From: Robert Mayhew  
Sent: 12 December 2016 18:15  
To: DC Consultation  
Subject: RE: Planning Application Consultation 16NP0103 Twice Brewed Inn, Bardon Mill, Hexham, Northumberland, NE47 7AN

16NP0103 - Construction of extension to public house for microbrewery at Twice Brewed Inn, Bardon Mill, Hexham, Northumberland, NE47 7AN

DRAWING TITLE:  
**SITE PLAN LAYOUT**

Drawing No:  
**CC/16/TWBDBY/1004**

PROPOSED SITE LAYOUT  
 Scale 1:250

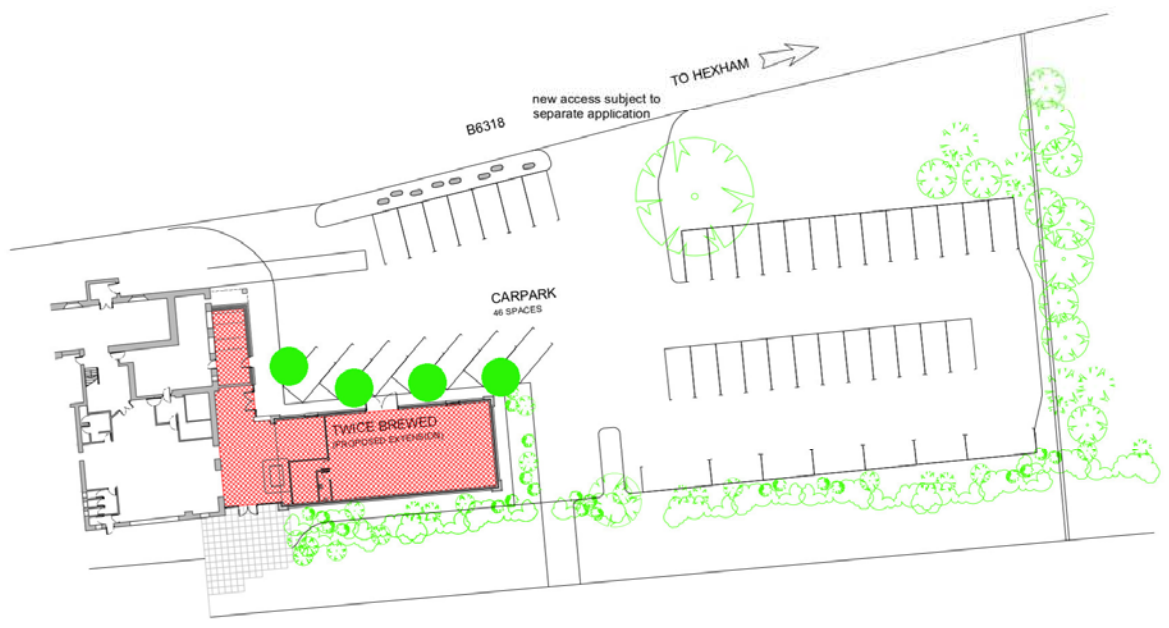
None the less, the proposals appear to extend the north and south elevations by approximately two thirds of the existing elevation and as such I do have concerns as to the effect that this would have on the landscape character and views of this part of the National Park, particularly when viewed from receptor sites to the north of the site. Unlike the adjacent Sill building being built next door, where there is a vegetative screen running along the north side of the building, the Twice Brewed Inn sits immediately adjacent to the Military Road and is clearly visible within the landscape when viewed from the raised elevations at on the Pennine Way and Hadrian's Wall National Trail at Windshields Crags and Steel Rigg for example. I believe that the effect that this proposed building extension will have on the surrounding natural landscape could be softened/mitigated if some form of appropriate landscaping could be incorporated into the car park to the north of the site. Our GIS records indicate that this should be possible without needing to plant directly into the scheduled area of the Vallum. (See attachment for suggested broadleaved tree planting locations).

In summary, I would like clarification as to the actual material to be used for the roof of the propose micro-brewery, would advocate that some landscaping is needed to the northern side of the proposed development to soften its effect on the landscape character and views given the sensitive location and finally ensure that any subsequent external lighting is managed via the use of a planning condition.

● Suggested locations for some selctive tree planting
